J. Zanesville Energy, LLC, Case No. 14-2254-EL-REN

Summary: Reply electronically filed by Mr. Bruce Bailey on behalf of Zanesville Energy, LLC

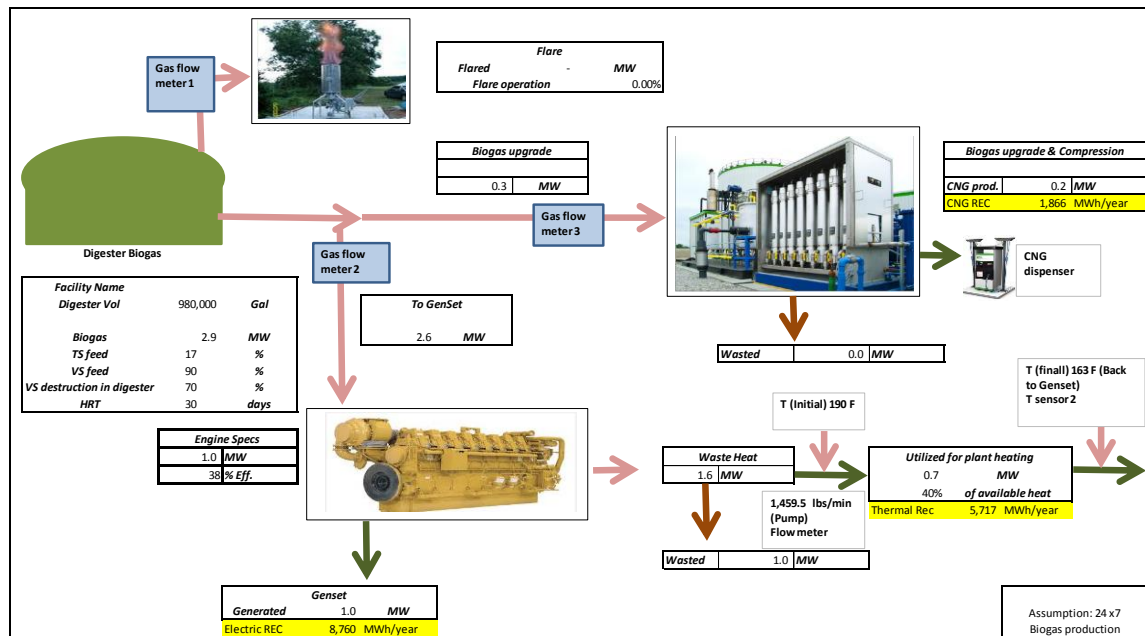
12. Regarding Section G.3 of the application, please provide a detailed description of how heat captured by each source is going to be measured and verified, including the configuration of the meter(s), the meter types(s), and meter accuracy. What is the projected in-service date of the thermal meters? Please provide documentation.
Thermal REC: Engine is cooled using a heat loop which circulates Glycol-Water mixture (50%) across the plant. The flow of the glycol is **175 GPM** (Pump rating, see fig.).

We have temperature sensor located in the engine which show the temperature of glycol taking waste heat from the engine. **The temperature is typically around 190° F (See fig. 1)** This glycol flows in the plant supplying heat for plant purpose (Digester heating, Floor heating, Pasteurization). **The return temperature of glycol is around 163° F (See fig. 1)**

$$\text{Heat utilized in the plant } \frac{\text{BTU}}{\text{min}} = 1,460 \frac{\text{lbs}}{\text{min}} * (190 \text{ F} - 163 \text{ F})$$

$$\text{Heat utilized in the plant } \frac{\text{BTU}}{\text{min}} = 39,808 \text{ BTU/min}$$

$$\text{Heat utilized in the plant } \frac{\text{BTU}}{\text{hr}} = 39,808 \frac{\text{BTU}}{\text{min}} * 60 \frac{\text{min}}{\text{hr}}$$

$$\text{Heat utilized in the plant } \frac{BTU}{hr} = 2,388,499 \frac{BTU}{hr}$$
